## Executive Director's Recommendation

<b>PROJECT</b> <b>Kennedy Center Expansion Connection Project</b> Kennedy Center for the Performing Arts 2700 F Street, NW Washington, DC	<b>NCPC FILE NUMBER</b> 7763
<b>SUBMITTED BY</b> Kennedy Center for the Performing Arts	<b>NCPC MAP FILE NUMBER</b> 23.00(38.00)44371
<b>REVIEW AUTHORITY</b> Federal Projects in the District per 40 U.S.C. § 8722(b)(1) and (d)	<b>APPLICANT'S REQUEST</b> Preliminary and final approval of site and building plans
	<b>PROPOSED ACTION</b> Approve as requested
	<b>ACTION ITEM TYPE</b> Staff Presentation

**NCPC File #: 7763**  
**Kennedy Center Expansion Connection Project**

**Preliminary and Final Review**

# Concept - Perspective Rendering Looking South along RCPP

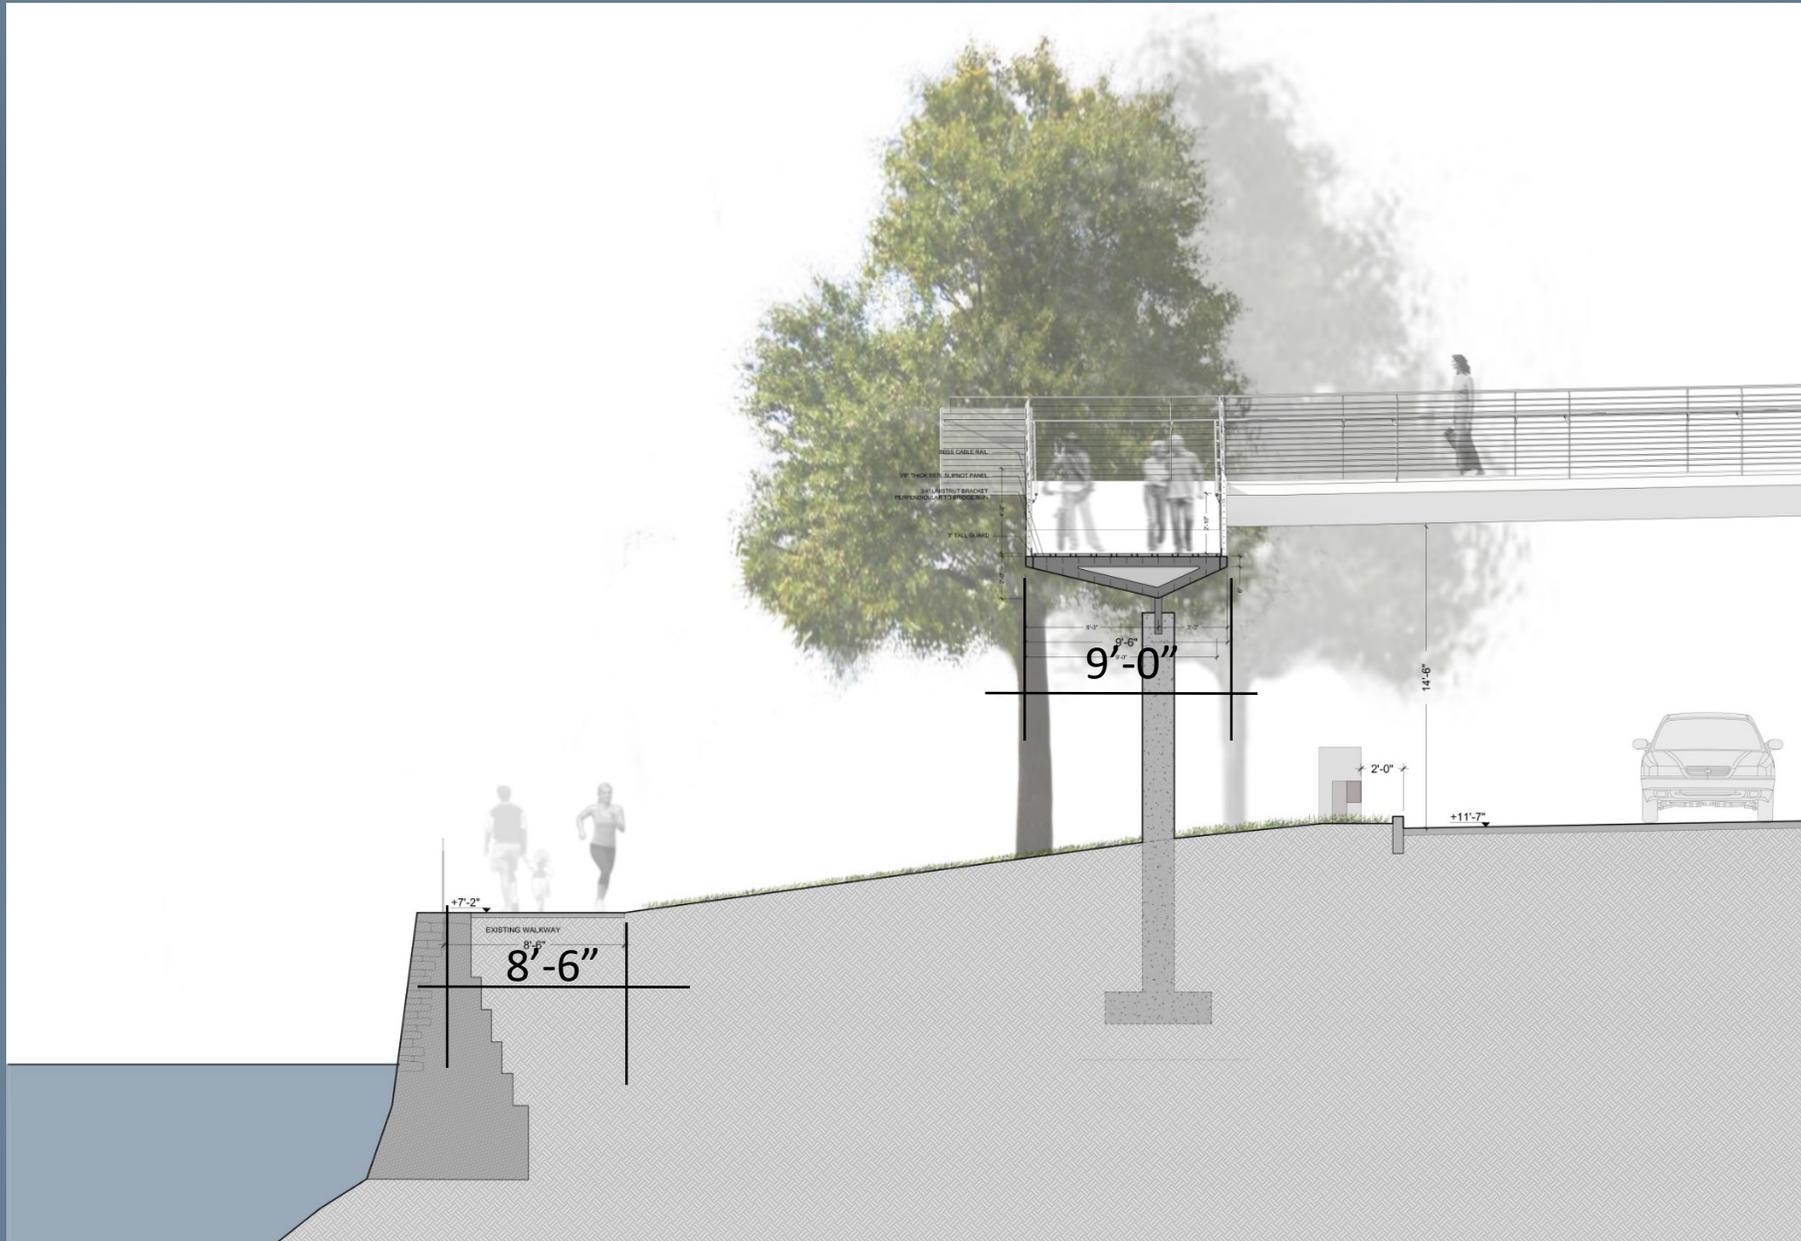
The Commission expressed support for a connection between the Kennedy Center Expansion and Rock Creek and Potomac Parkway during the concept review in April 2016. The Commission also raised several concerns at that time regarding the bridge's character, circulation, and design details. Staff finds that the Kennedy Center has addressed these concerns and therefore recommends that the Commission **approve the preliminary and final site and building plans for the Kennedy Center Expansion Connection Project which is an important link to the regional trail network improving access between the Kennedy Center, the Potomac waterfront and the National Mall.**

**Commission Action:** Requested that the character of the Expansion Connection be further evaluated from an urban design and historic preservation perspective as it relates to both the Kennedy Center expansion as well as the Parkway. For example, evaluate (1) whether it may be perceived as an independent infrastructure element or as an architectural extension of the Kennedy Center expansion; and (2) how it will address the Parkway, which includes park and transportation purposes.

**Kennedy Center Response:** *The Kennedy Center design team, Steven Holl Architects (SHA), maintains its support for a proposed bridge and ramp design that responds to the Kennedy Center building and not the parkway. This decision is based on the unique structure that SHA is proposing – no other pedestrian-only bridge crosses over the parkway. In addition, the other parkway bridges, which carry vehicles and pedestrians require a much more substantial structure in order to carry the vehicular loads and span the parkway. As the proposed bridge has a very different purpose, allowing pedestrians to*

**Staff Comments:** Staff agrees that this is a unique structure along the parkway. In addition, this segment of the parkway is unique in that it is by bounded the west terrace of the Kennedy Center to the north and the Theodore Roosevelt Memorial Bridge (I-66) to the south. As such, staff supports a bridge design that takes guidance from the character and context provided by the Kennedy Center and the new expansion project. In addition, staff notes the Commission of Fine Arts (CFA) at its meeting in May 2016, reviewed the concept design and supported the design as an extension of the Kennedy Center and the expansion project and "...commended the project team for an elegant and well-detailed bridge connecting to the Rock Creek and Potomac Parkway...". CFA approved the final design at its meeting on June 16, 2016. Staff is satisfied with this response.

# Perspective Rendering Looking West from River Pavilion

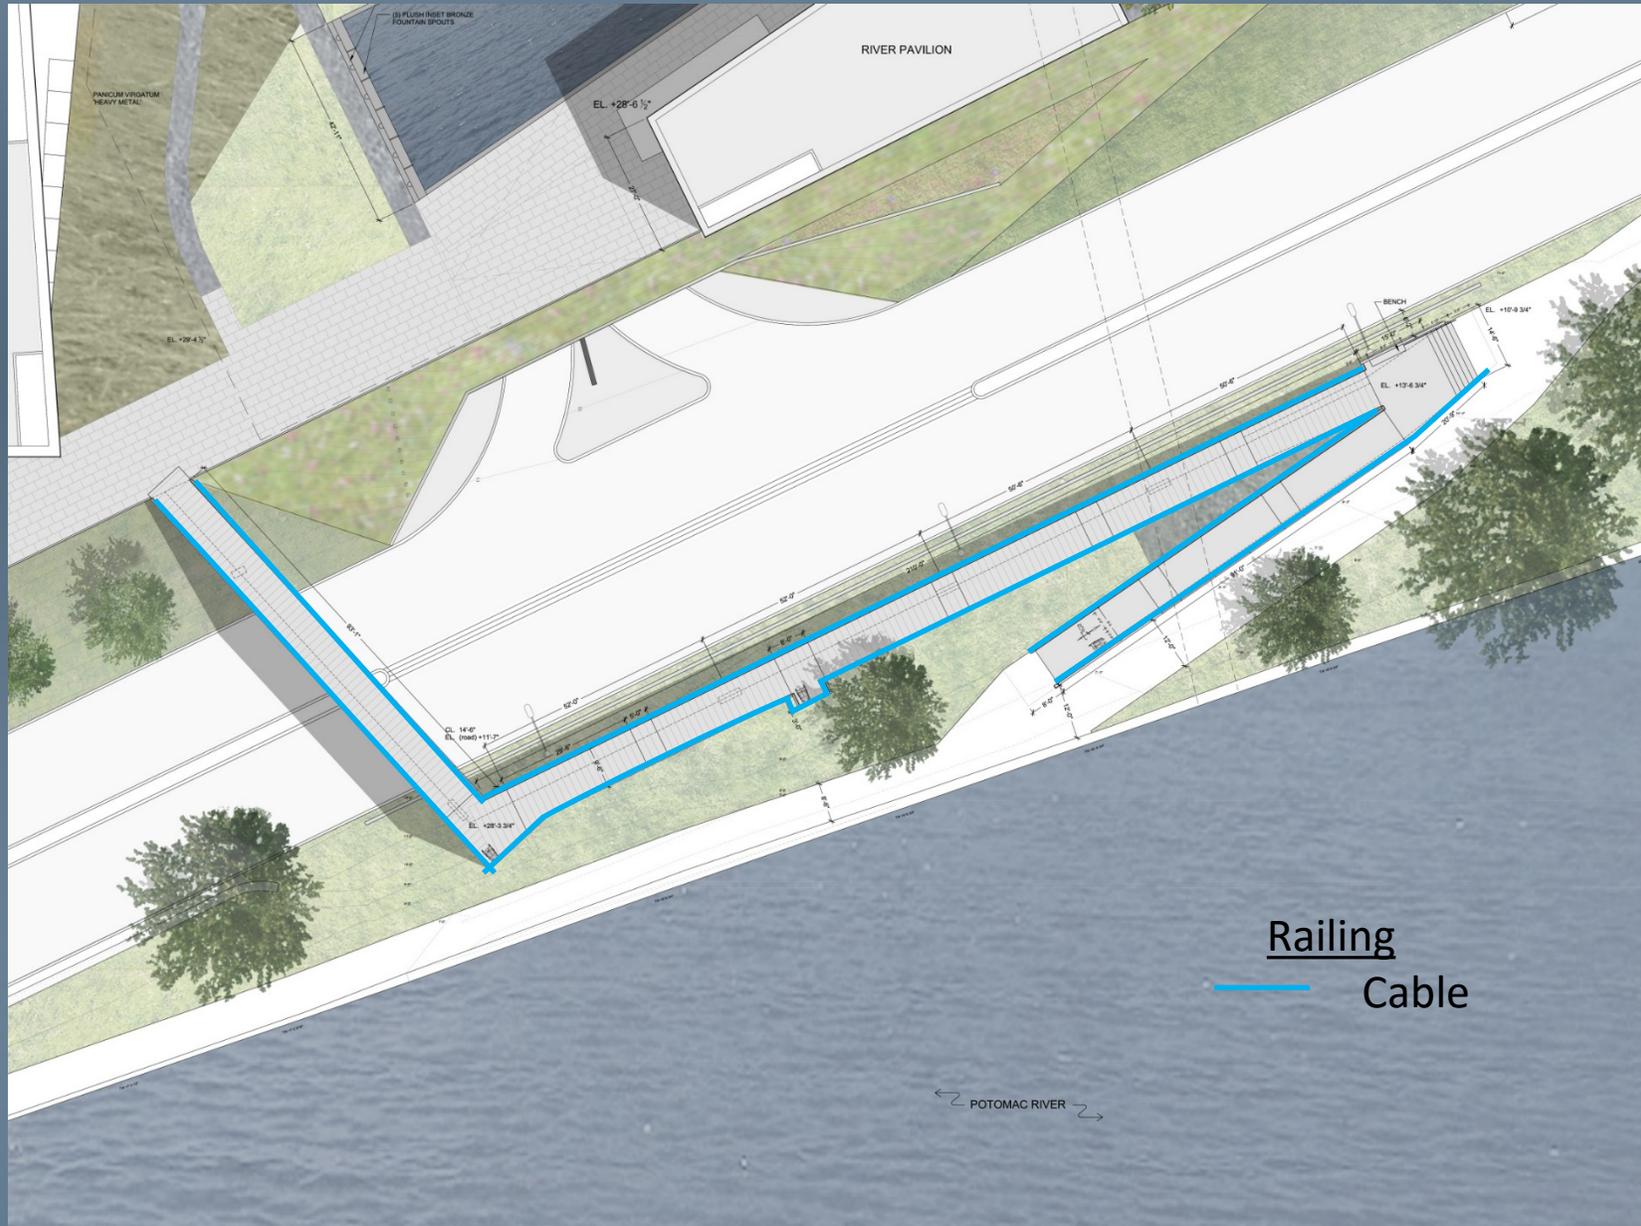
**Commission Action:** The Kennedy Center provide a circulation map, renderings and detailed plans that clearly delineate the various elements, including ramps, stairs, landings and the bridge, as well as the route which connects to the Theodore Roosevelt Bridge trail. This next submittal should demonstrate that this facility is wide enough to handle the anticipated capacity and demonstrate how the ramps and landings will be oriented to ensure continued functionality of the paved recreation trail and improve sightlines for both trail users and visitors to the Kennedy Center.

**Kennedy Center Response:** *The Kennedy Center noted that the bridge connection to the Kennedy Center Expansion Project was placed at an important point - the intersection of the trail connection to the Theodore Roosevelt Bridge trail, the plaza connection to the River Pavilion, and a walkway connection up to the Kennedy Center itself. The bridge location is also influenced by a few factors, namely, the narrow strip of land where it connected to the Rock Creek Paved Recreation Trail, the clearance height of the bridge for bus traffic and ADA accessibility purposes.*

*SHA responded to the Commission's April 2016 concept design concern about the potential conflicts between trail users and Kennedy Center visitors. These conflicts were located at the two connection points where the proposed bridge project connected to the Rock Creek Paved Recreation Trail. SHA's response was to move the switchback ramp to the south by extending the stairs which then allowed it to shift the ramp slightly to the east. This change now allows for a larger landing at the end of both the ramp and the stairs.*

**Staff Comments:** Staff understands that the bridge connection to the Expansion Project occurs at the intersection of several key movements and is influenced by significant site constraints. As noted by the applicant, the primary site constraint is the narrowness of the site where the ramps must land on NPS property, immediately west of the parkway travel lanes. At its narrowest point, the area is approximately 37 feet wide. The Rock Creek Paved Recreational Trail is 12 feet wide to allow for better sight lines in this section of the trail, and the ramps are 9.5-foot each for a total of 19 feet. This leaves approximately 6 feet for a setback from the travel lanes. Staff believes the Kennedy Center's ramp width is appropriate as it best balances impacts to the location and width of the existing trail, along with the placement of the ramps in relationship to the parkway. Staff also notes that the

In addition, staff finds that this separate landing for the ramp and stairs allows for people to move out of the way of the pedestrian flow on the trail. In shifting the trail to the south and slightly east, the ramp and stair landings appear to be more substantial as well as more clearly differentiated from the existing trail. Staff believes this is safer for both the trail users and the Kennedy Center visitors as it will provide more space and greater visibility for improved safety. In addition, the trail width will be increased in this area, up to a total of 12 feet, that will provide sufficient space for trail users to safely pass by this area. Staff is satisfied with this response and the design revision.
